MEMORANDUM

SUBJECT: Supplemental Report - BZA Case No. 19053 – Ridge Lofts – 446-452 Ridge St. NW

Board of Zoning Adjustment
District of Columbia
CASE NO. 19053

Figure 4: Weekday Peak (PM) Parking Occupancy (Source: Grove/Slade)

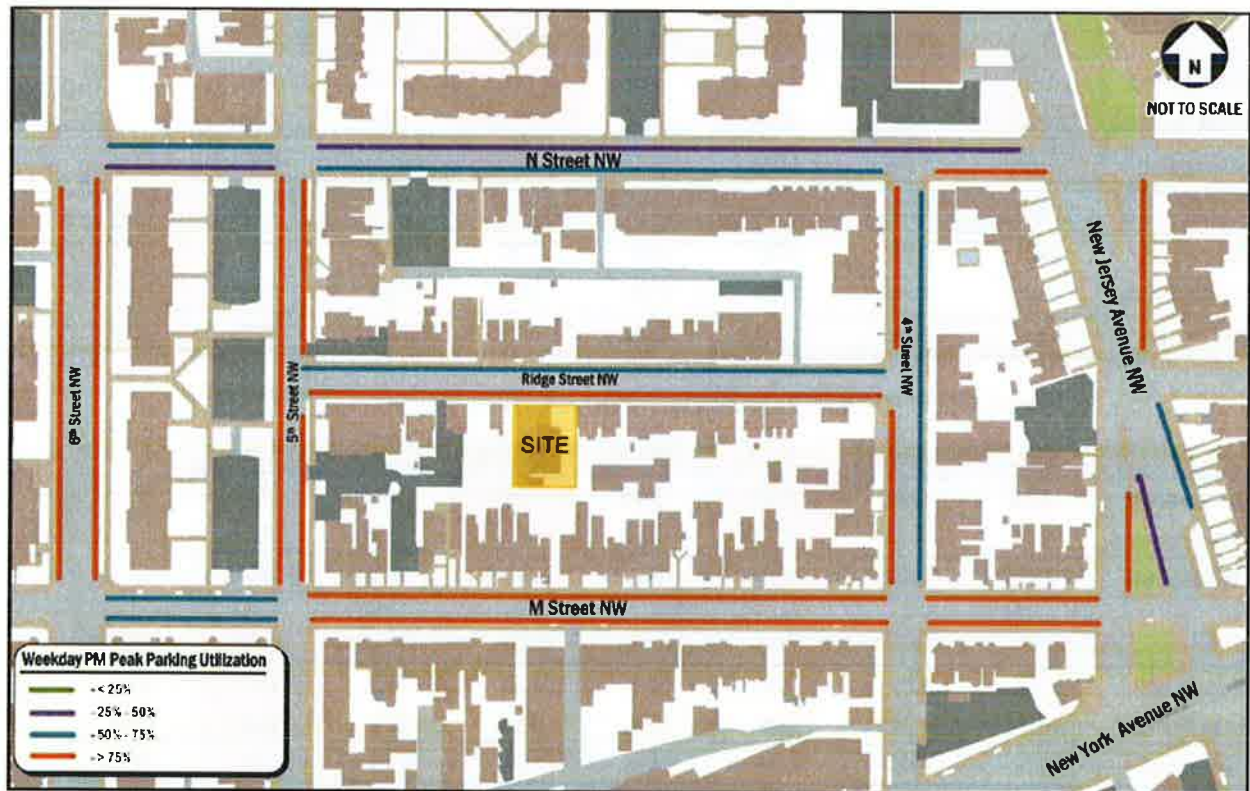
Zoning requires the provision of four parking spaces for the proposed eight dwelling units located on four lots. The Applicant requests full parking relief. While this variance request does not meet DDOT's threshold for a vehicle parking occupancy study, a study was conducted by the Applicant. Parking occupancy data was collected on Saturday, September 12, 2015 and Tuesday, September, 15, 2015 from 7:00 am to 9:00 pm on each day. Street sweeping was not scheduled for either day. This analysis shows unused nearby on-street parking that would meet the proposed project's parking demand (see Figures 1, 2, 3, 4, and 5), with 80 spaces available during peak weekday demand in the study area (9:00 pm to 10:00 pm) and 47 spaces available during peak Saturday demand in the study area (8:00 pm to 9:00 pm). Additionally, Figures 4 and 5 show that on the 400 block of Ridge Street, where the proposed development is planned, parking utilization is between 50% and 75% on the north-side of the street and greater than 75% on the south-side of the street during peak weekday demand and greater than 75% on both sides of the street during peak Saturday demand. DDOT finds that the available parking spaces will accommodate the expected peak hour site generated vehicular trips and parking demand.
